MATERIALS LICENSE

Licensee		3. License Number
1. Newark Medical Associates, P.A.		29-30282-01
2. 810 Broad Street Newark, New Jersey 07102		4. Expiration Date
		September 30, 2001
		5. Docker or Reference No.
		030-34086
6. Byproduct, Source, and/or Special Nuclear Material	7. Chemical and/or Physical Form	8. Maximum Amount that Licensee May Possess at Any One Time Under This License
A. Any byproduct material identified in 10 CFR 35.200	A. Any radiopharmaceutical identified in 10 CFR 35.200 except generators and gas	A. As needed
9. Authorized use		
A. Any imaging and localization procedure approved in 10 CFR 35.200.

SUBJECT: APPLICATION FOR MATERIAL LICENSE DATED February 21, 1996, AND
OUR REQUEST FOR INFORMATION DATED March 16, 1996

This is in reference to your application dated February 21, 1996 for a byproduct materials license.. In order to continue our review, we need the following additional information:

STORAGE ROOM

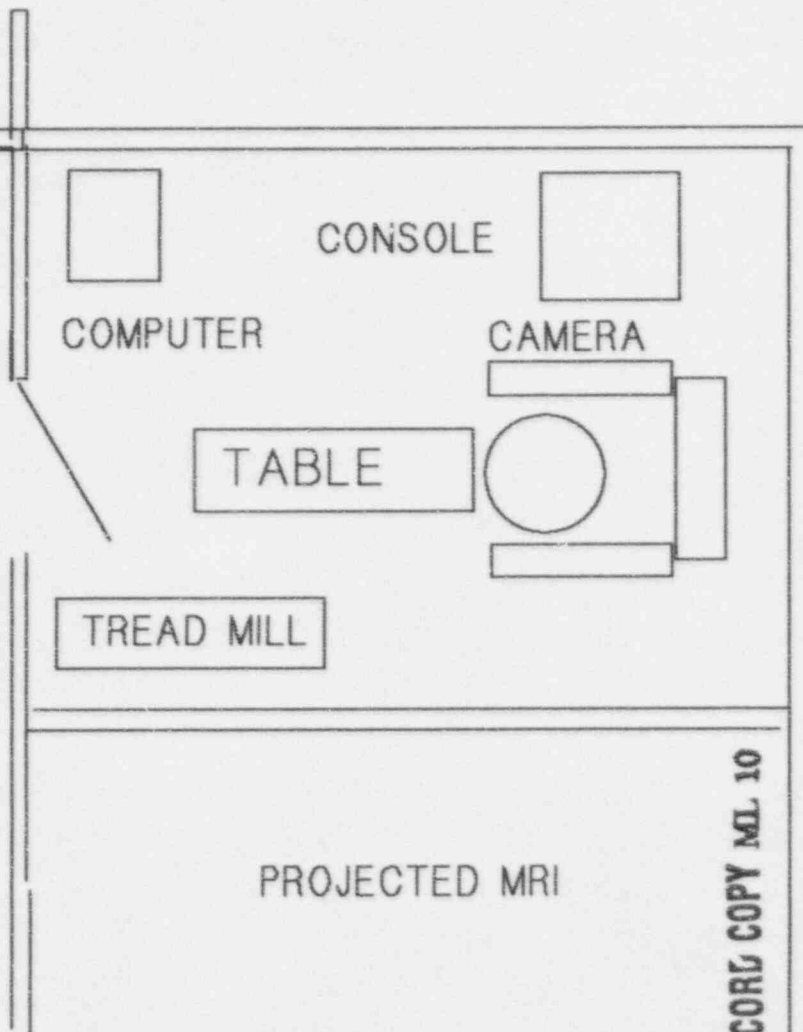
3. On a detailed version of your Hot Lab diagram, please indicate the position of each of the areas described below and describe the type, dimensions, and thickness of shielding that you will use:

- a. Storage of radiopharmaceuticals (refrigerated and nonrefrigerated).
 - b. Storage of radioactive waste, including decay-in-storage prior to disposal as nonradioactive waste.

In addition, identify adjacent areas across the walls from use and storage locations and show that adequate steps have been taken to assure that radiation levels in unrestricted areas will not result in doses to individual members of the public in excess of those specified in 10 CFR 20.1301 (enclosed).

2. Our Survey Meters will be calibrated by RMC Calibration Services, Wilmington, Delaware, NRC License No. 07-30114-01.
 3. Since we initially filed our application, we moved the scanning room to the north side of the hallway, adjacent to the hot lab. On a sturdy bench, we located a standard Nuclear Associates L-shield for dose preparations and storage of dose calibrator reference sources. The lead bricks are standard lead bricks with a 2" thickness.

- a. As a rule, we do not intend to store radiopharmaceuticals and we will essentially use Tc-99m labeled radiopharmaceuticals.
 - b. We will store any non-used materials as well as decaying waste in the small room at the end of the hot lab marked isotope storage, in special lead lined waste containers.

- The north end of the isotope storage room is an outside wall.

The east side of the hot lab is made of a very thick wall. On the other end of the wall is an emergency type staircase, inaccessible to the public.
